DANSVILLE SCHOOLS ADDITION / RENOVATIONS

ISSUANCES DATE
CONSTRUCTION SET 07/31/2017

Revisions		
No.	Date	Description
PBA2	06/19/2017	POST BID ADDENDUM 2

SHEET TITLE
LOWER COMPOSITE
PLAN

1 LOWER COMPOSITE PLAN
1" = 20'-0"

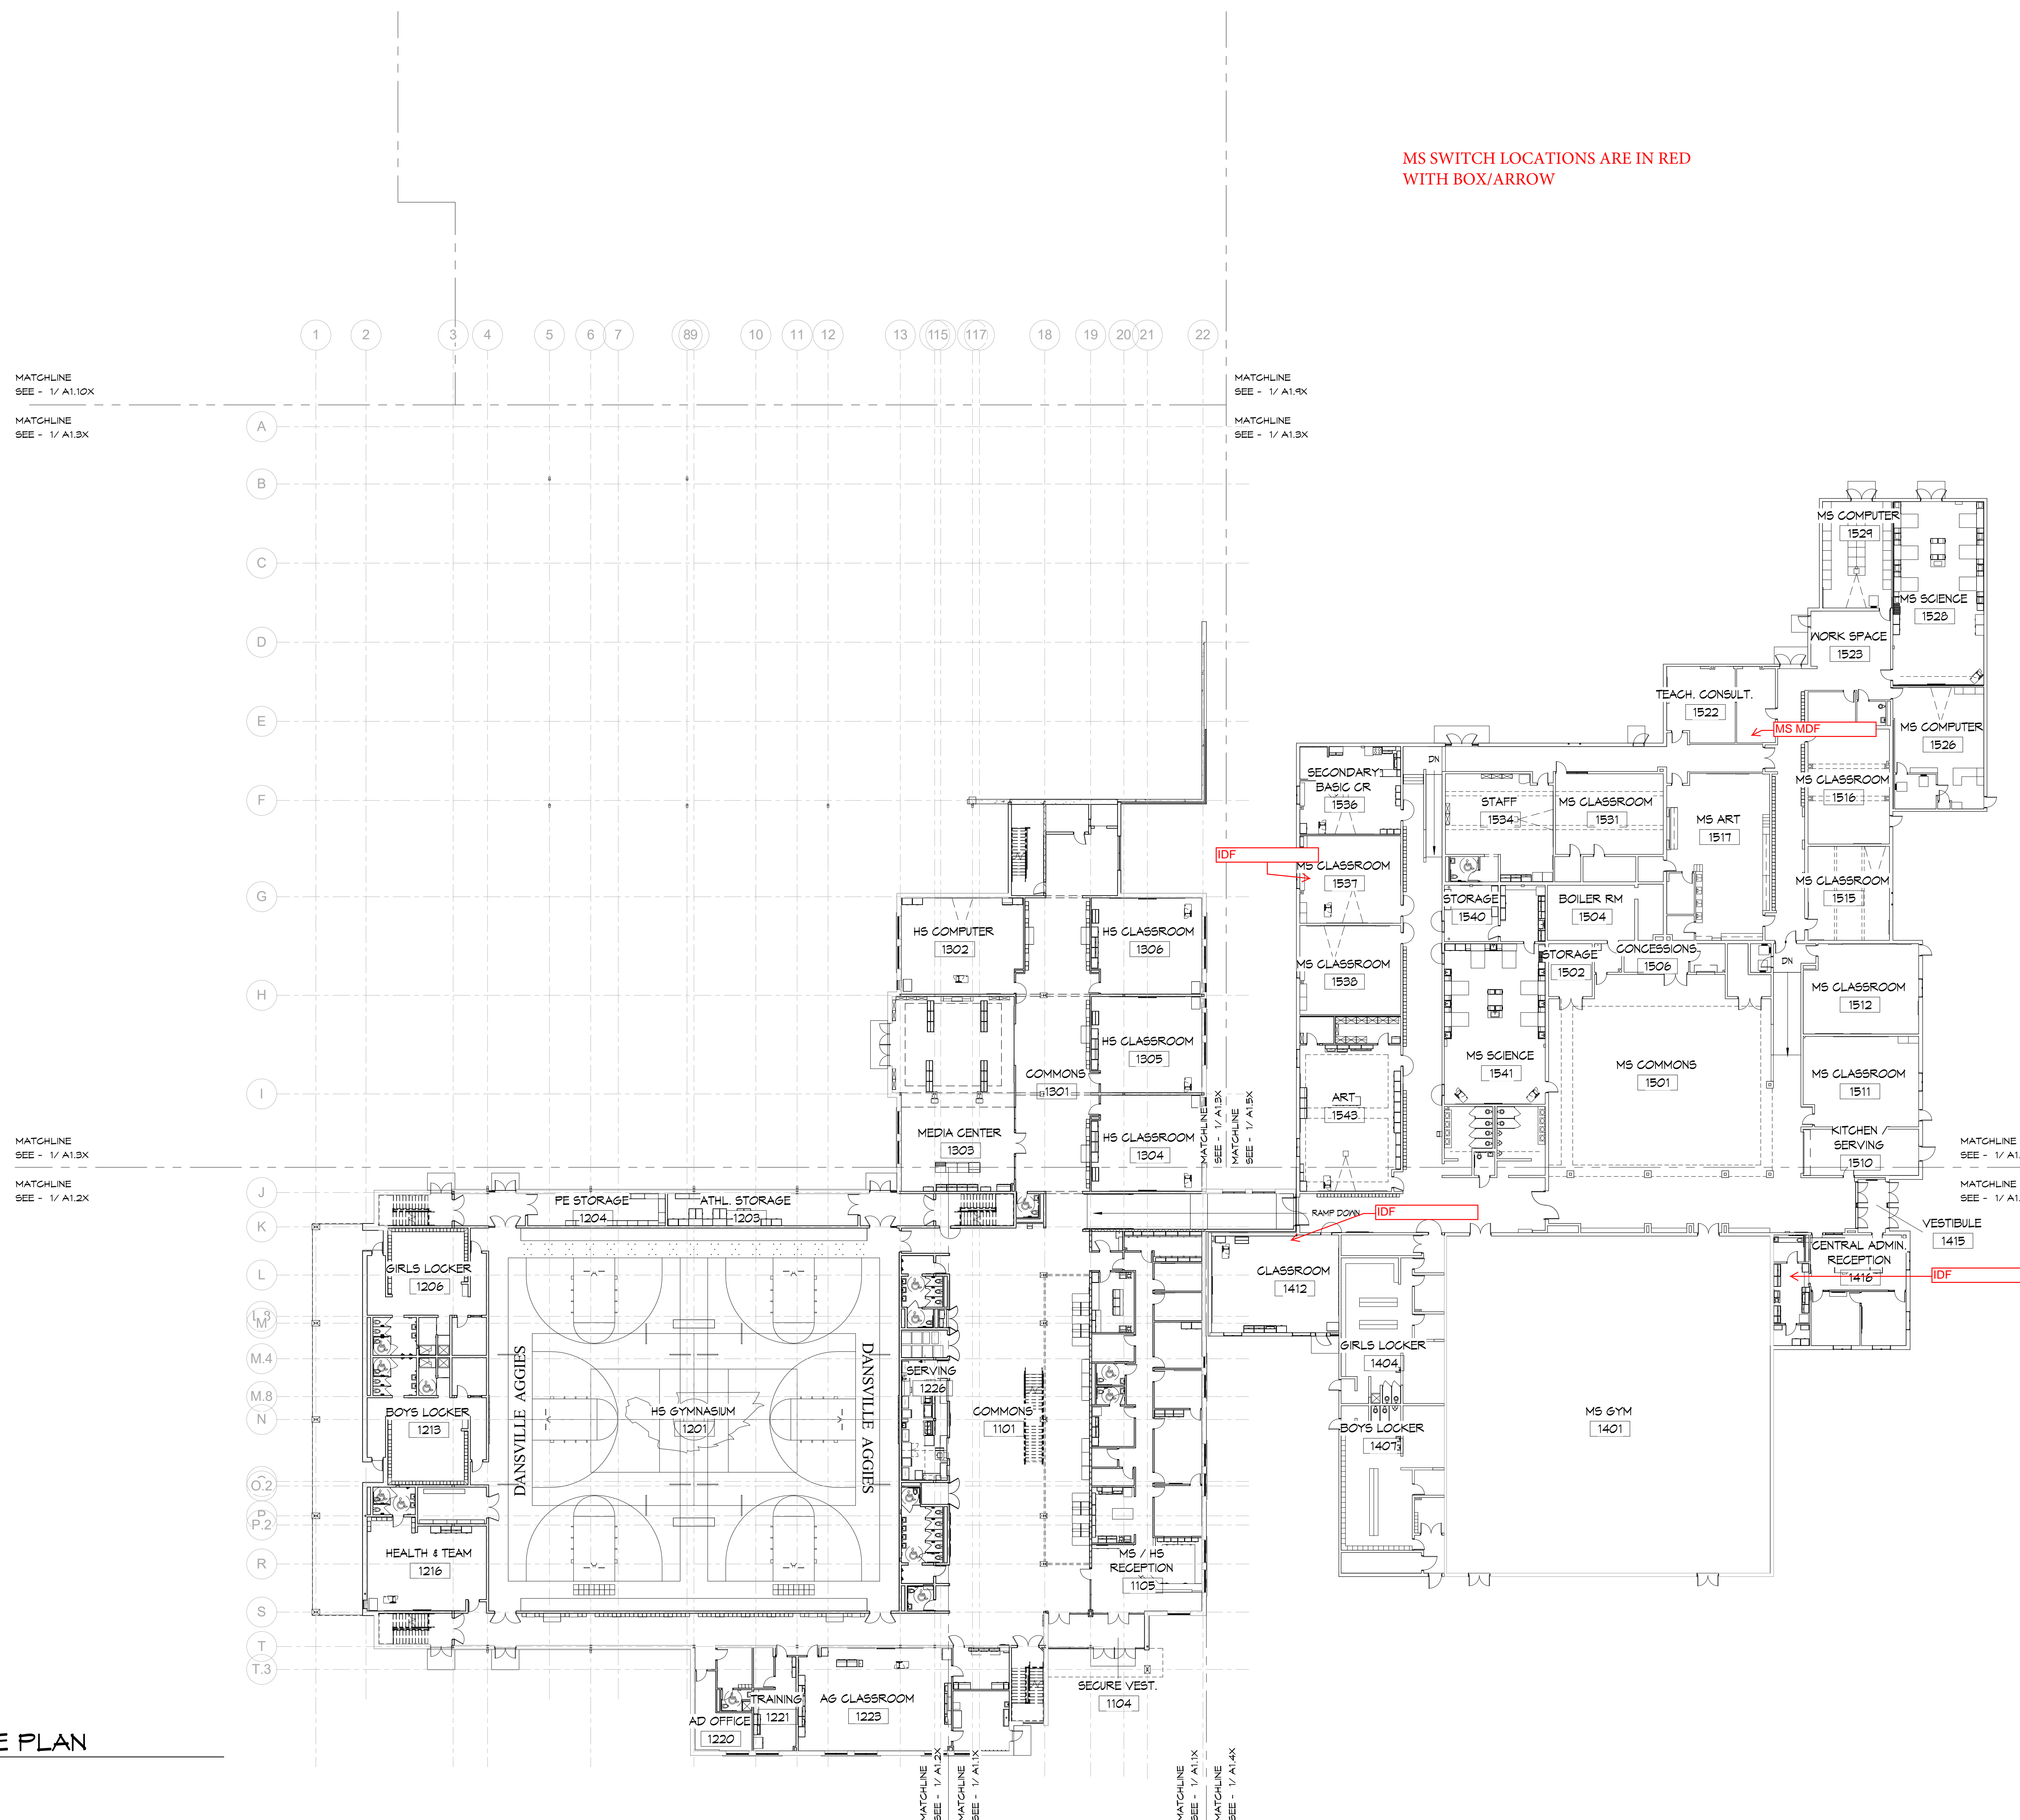
MS SWITCH LOCATIONS ARE IN RED
WITH BOX/ARROW
